Revision History

Revision 1 - March 2, 2007. Updated based on new SNW-3 speed negotiation window, and multiplexing.

Overview

Figure 117 — SP (phy layer) state machine - OOB sequence states

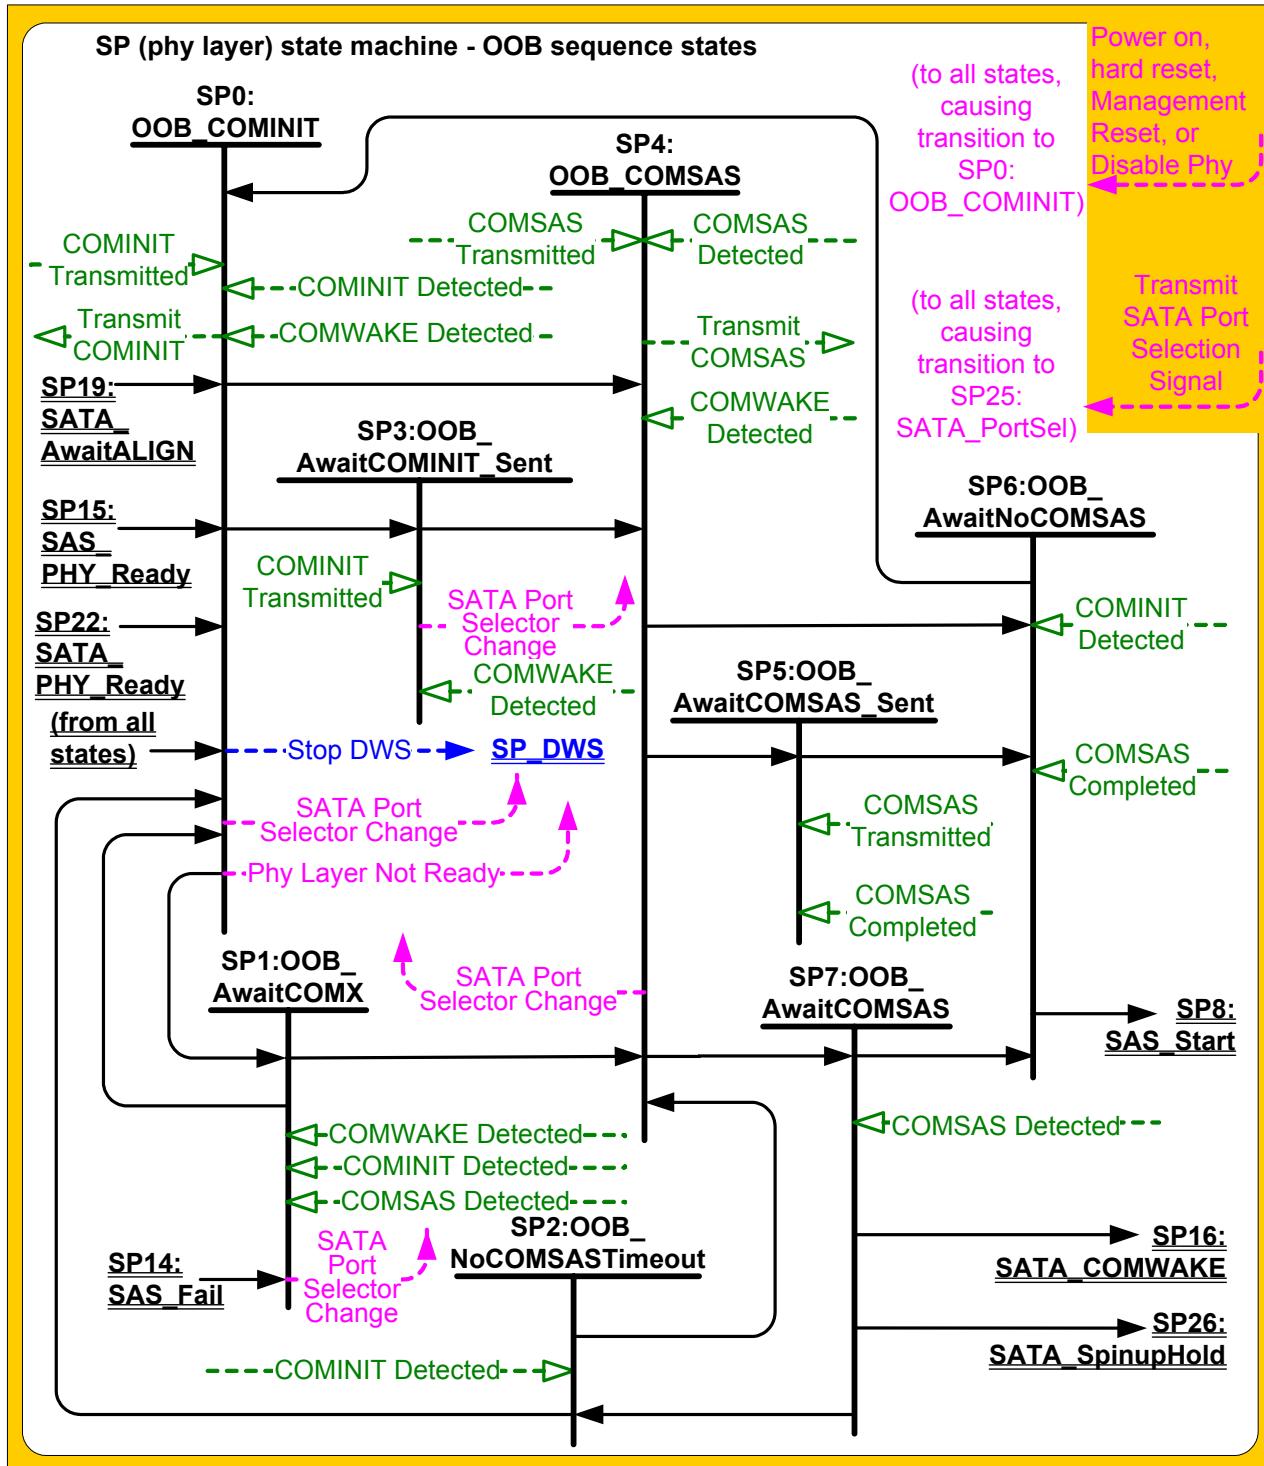
[Before the transition, if this state was entered from SP0:OOB_COMINIT, this state shall set the ResetStatus state machine variable to UNKNOWN.](#)

[Editor's Note 1: This is to get the variable cleared when there isn't a device responding to anything anymore, and not have lingering RESET_IN_PROGRESS, PHY_RESET_PROBLEM, etc.](#)

Figure 118 — SP (phy layer) state machine - SAS speed negotiation states

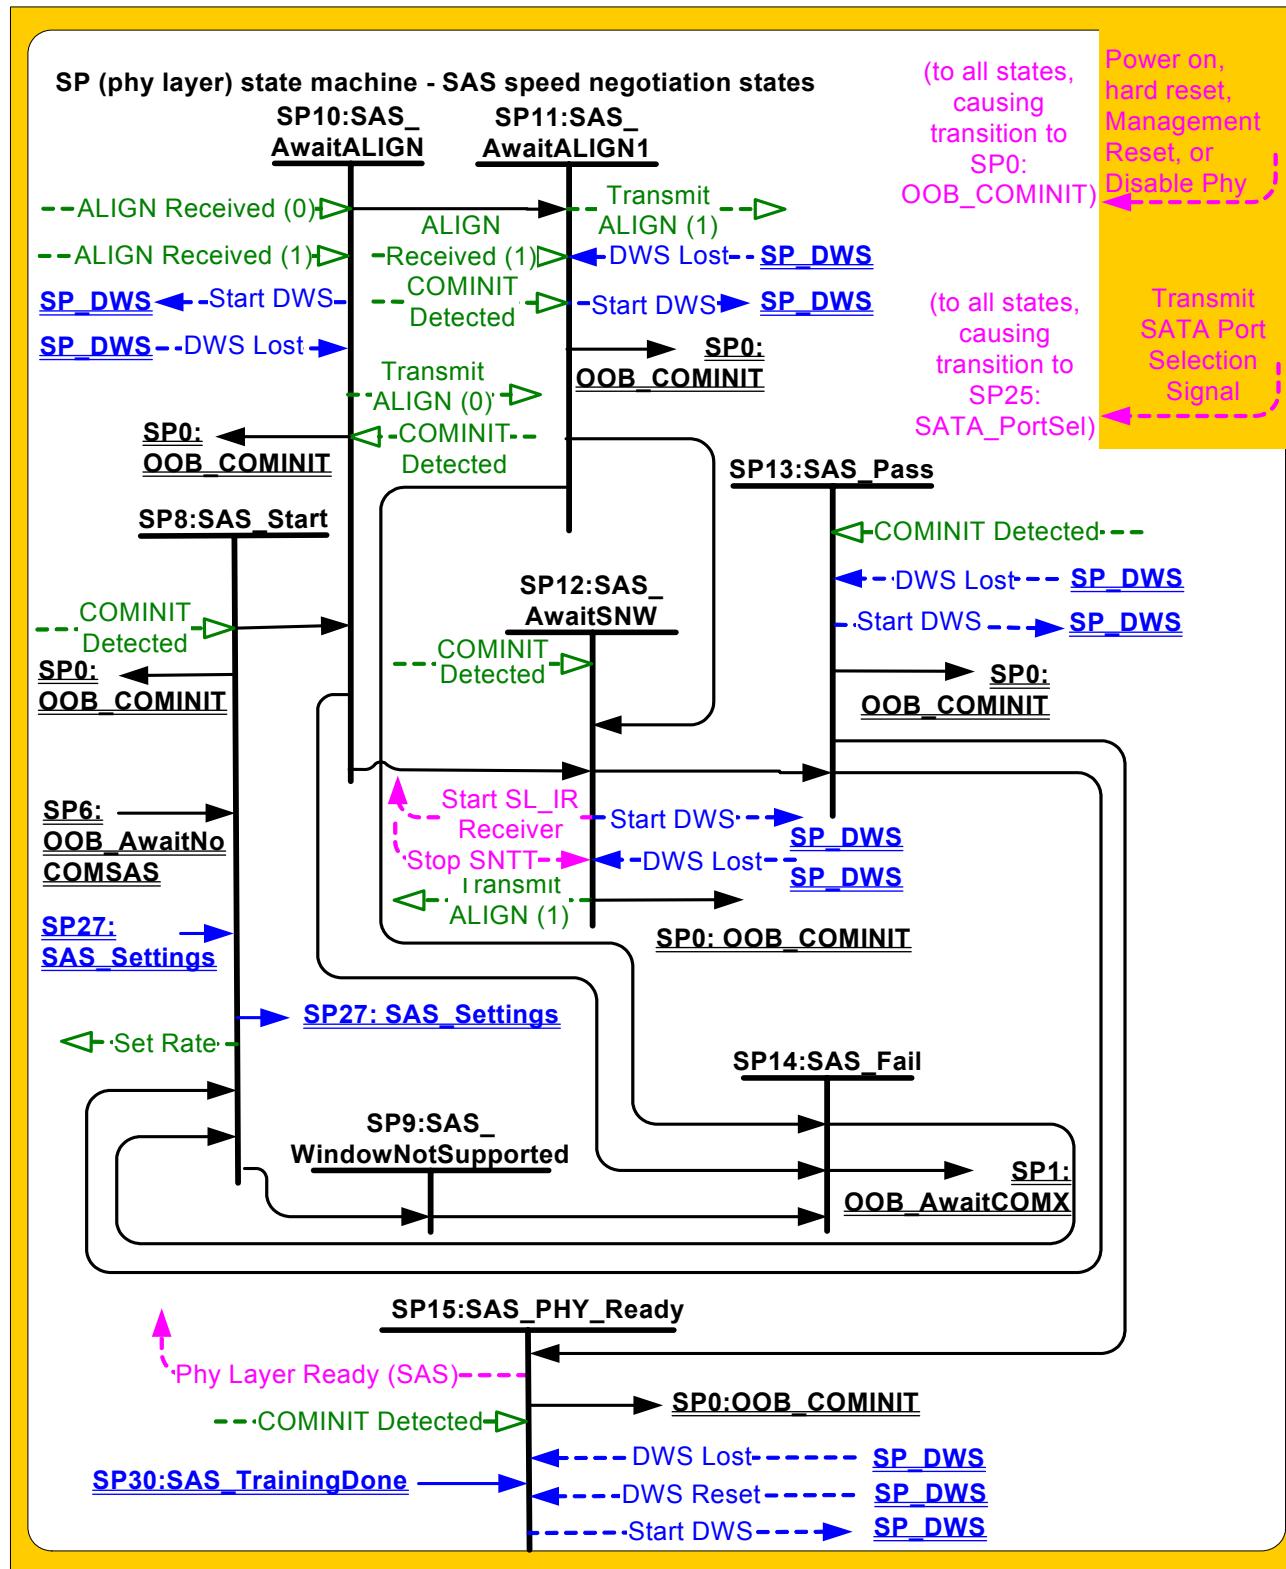
Editor's Note 2: Should this transition (and some others based on receiving a COMINIT) set the ResetStatus variable to UNKNOWN?

Before the transition, this state shall set the ResetStatus state machine variable to PHY_RESET_PROBLEM.

Figure 120 — SP (phy layer) state machine - SATA host emulation states

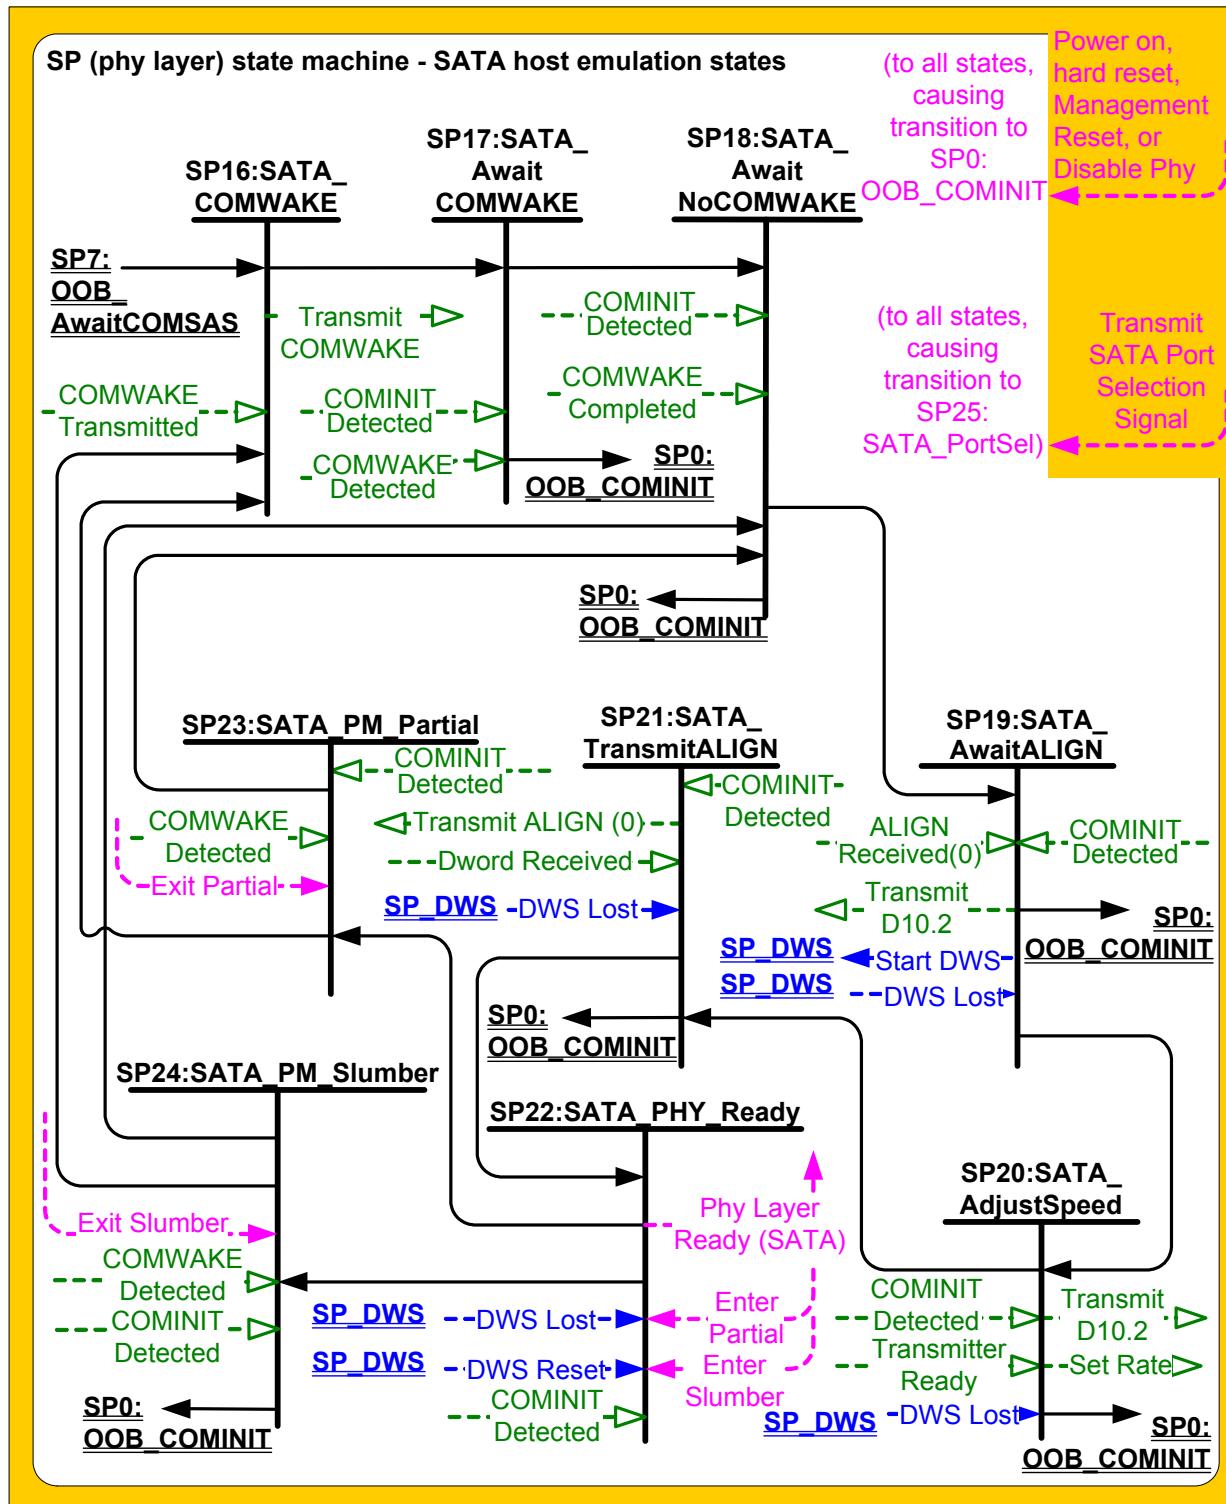
Editor's Note 3: Or should this be either PHY_RESET_PROBLEM, or UNSUPPORTED_PHY_ATTACHED? PHY_RESET_PROBLEM would be a technical change since that was used for SAS only in the past.

Figure 121 — SP (phy layer) state machine – SATA port selector state

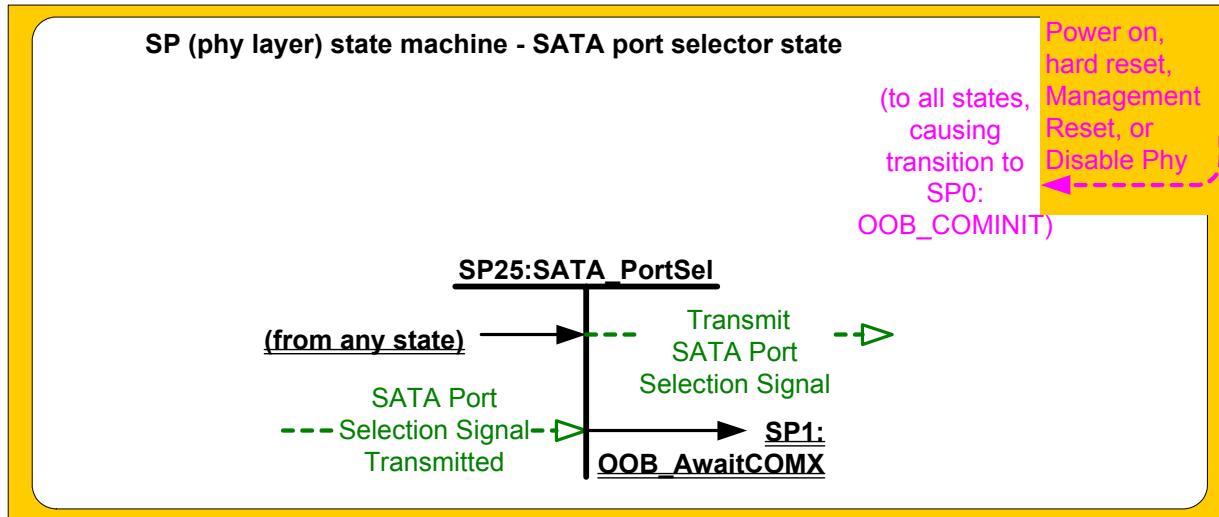
- [set the ResetStatus state machine variable to UNKNOWN;](#)
- send a Transmit SATA Port Selection Signal message to the SP transmitter;
- set the ATTACHED SATA PORT SELECTOR bit to zero in the SMP DISCOVER response (see 10.4.3.7) and the SMP DISCOVER LIST response (see 10.4.3.13.3); and
- set the ATTACHED SATA DEVICE bit to zero in the SMP DISCOVER response and the SMP DISCOVER LIST response.

Figure 122 — SP (phy layer) state machine - SATA spinup hold state

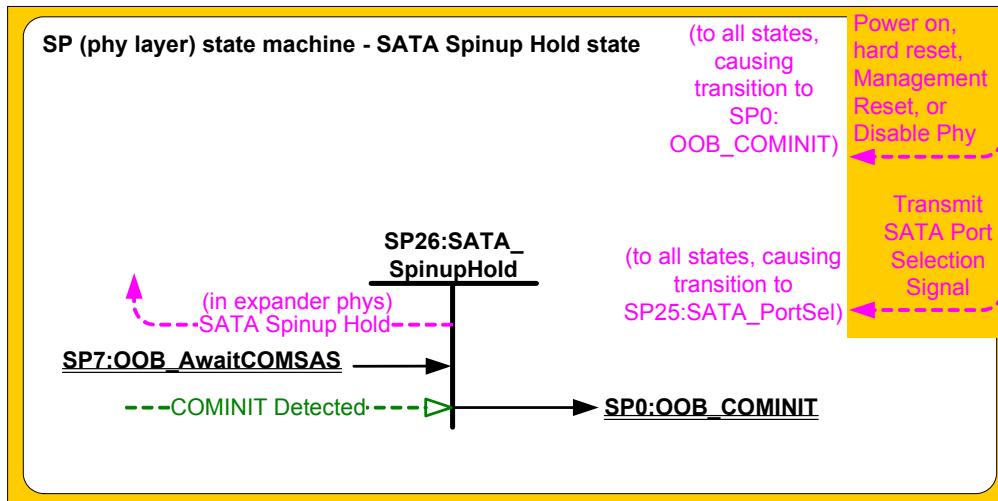
[Upon entry into this state, this state shall set the ResetStatus state machine variable to SPINUP_HOLD.](#)
